Addendum 1

June 16, 2025

Fort Wayne Airport JEKCC Infrastructure Improvements

Description: Modification Section P – Bid Item Schedule

E1.2

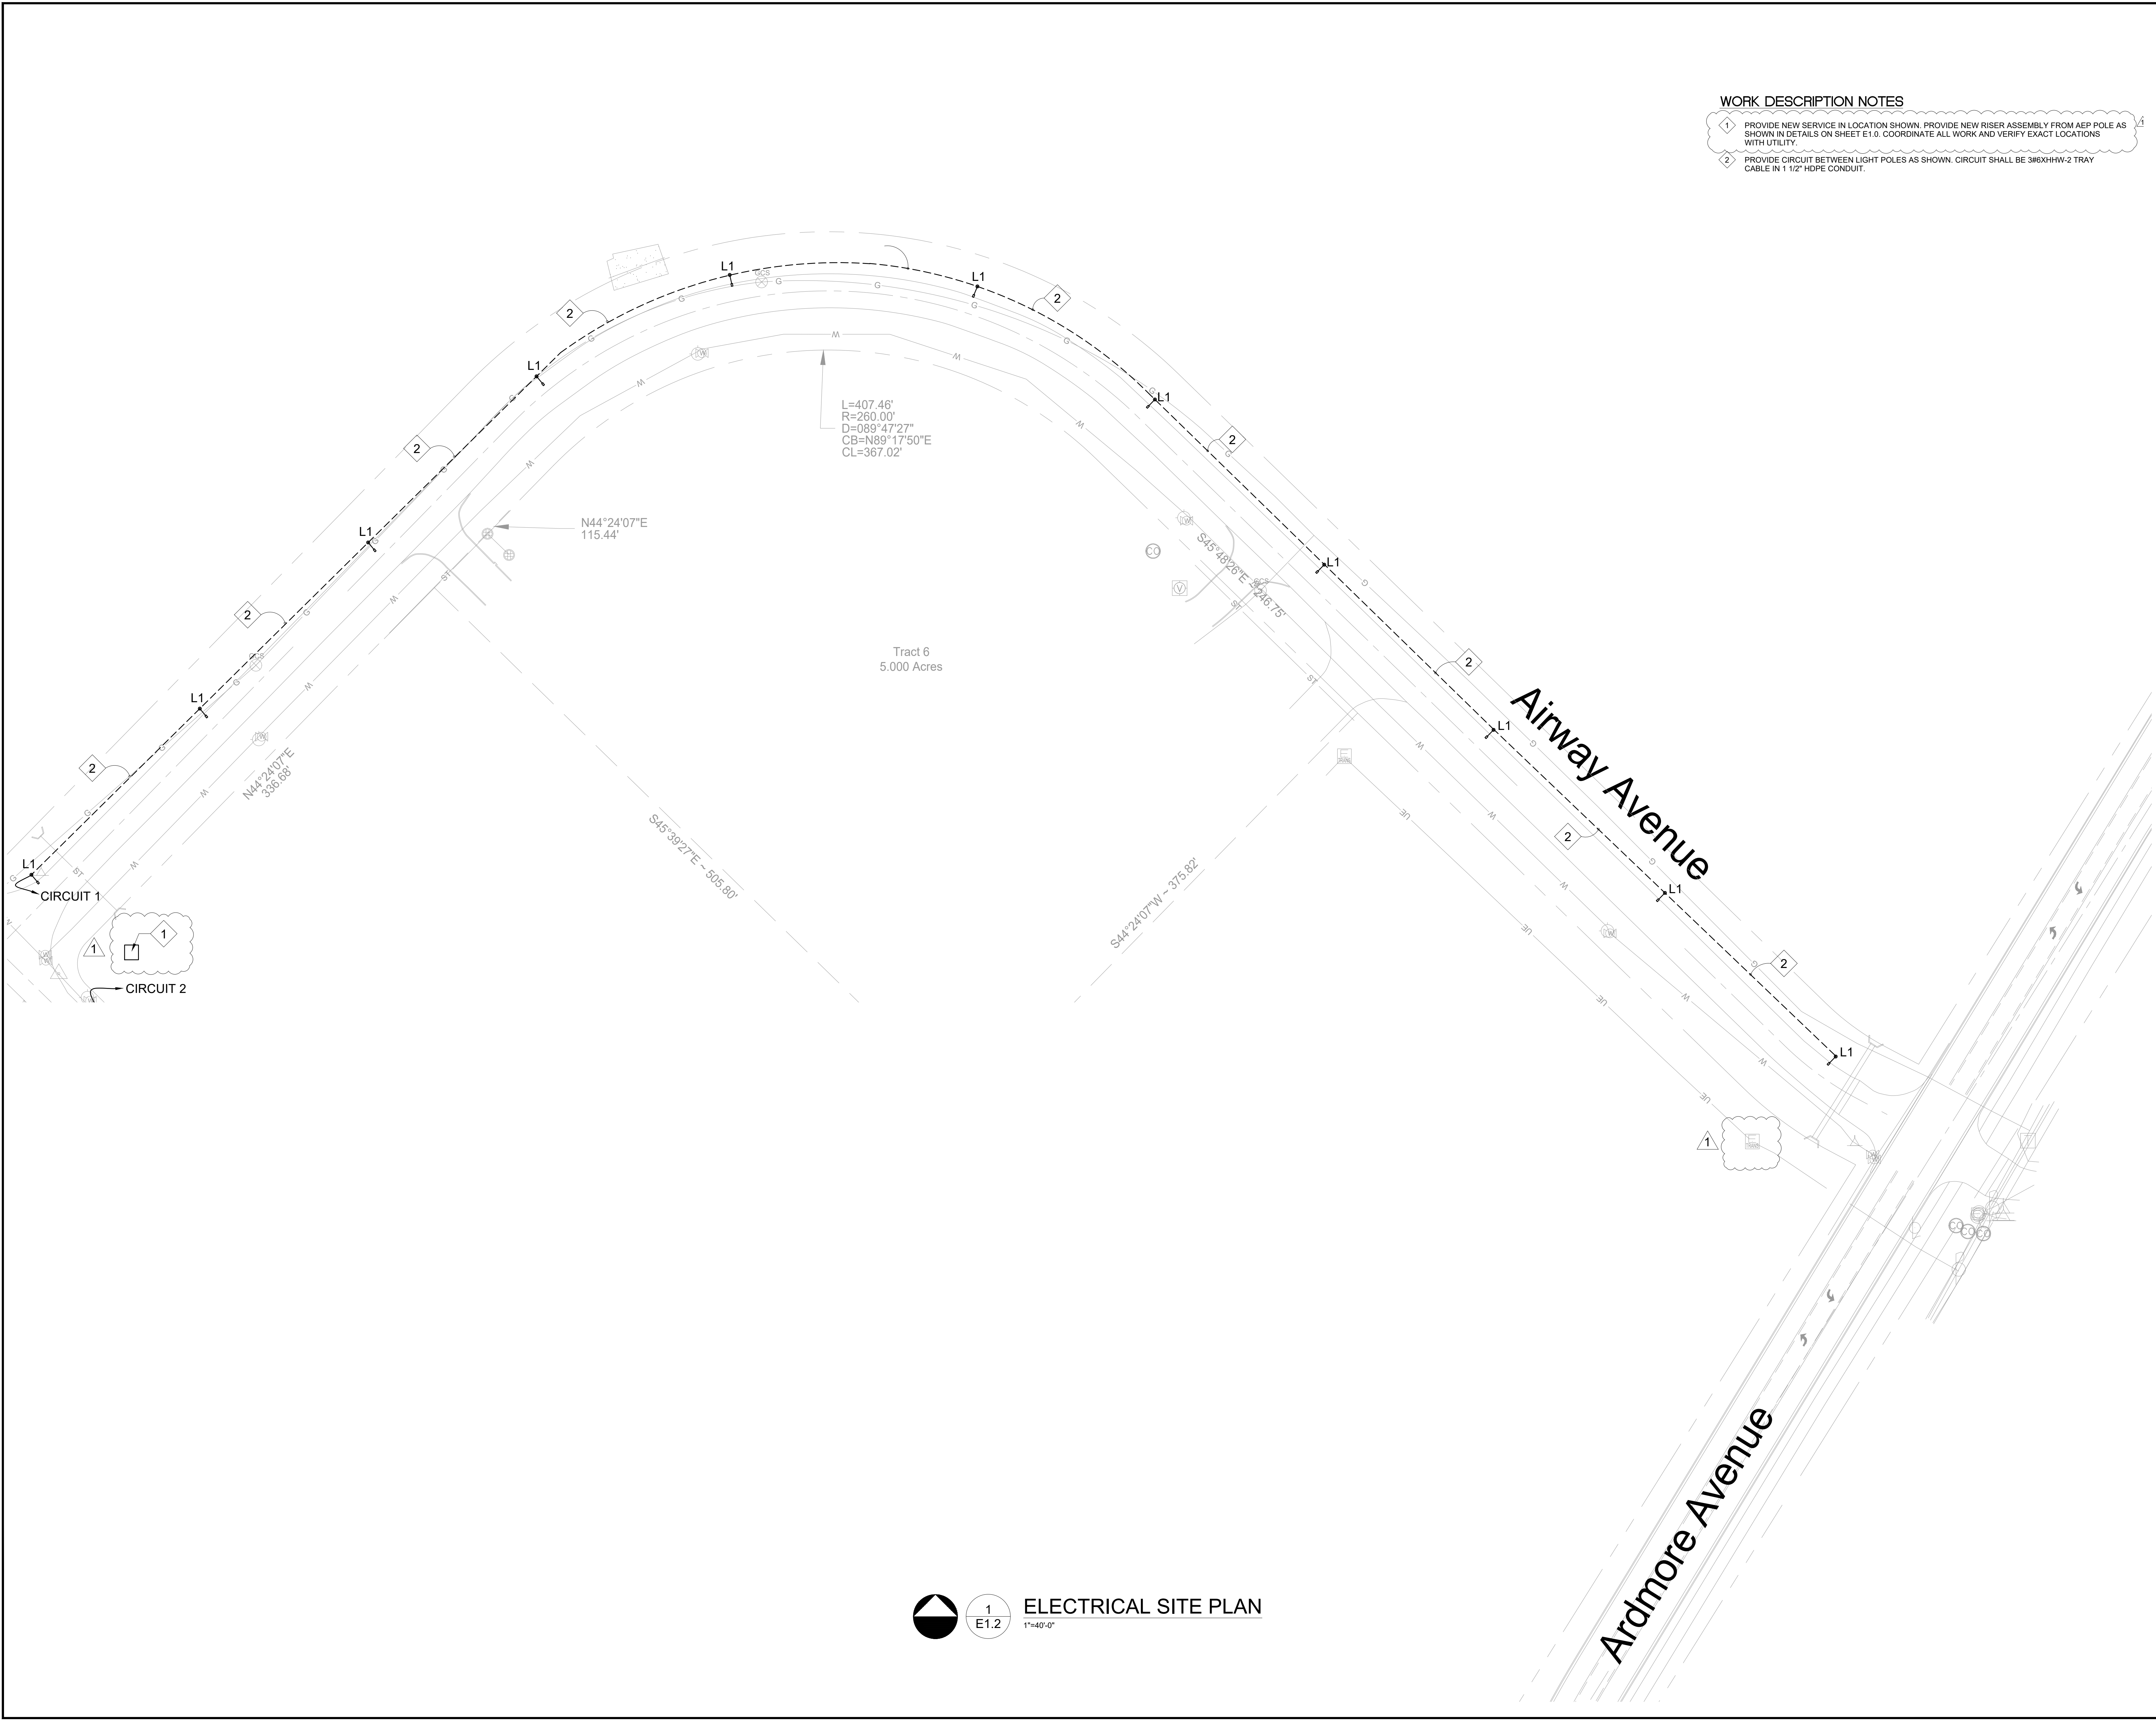
- A. Change of Work Description Note #1 from “New Power Source” to “New Service” and clarification of location from AEP Pole on E1.1, E1.2, and E1.3.
- B. Removal of new power source tag at intersection of Airway Avenue and Ardmore Avenue.

- 1 PROVIDE NEW SERVICE IN LOCATION SHOWN. PROVIDE NEW RISER ASSEMBLY FROM AEP POLE AS SHOWN IN DETAILS ON SHEET E1.0. COORDINATE ALL WORK AND VERIFY EXACT LOCATIONS WITH UTILITY.
- 2 PROVIDE CIRCUIT BETWEEN LIGHT POLES AS SHOWN. CIRCUIT SHALL BE 3#6XHHW-2 TRAY CABLE IN 1 1/2\"/>
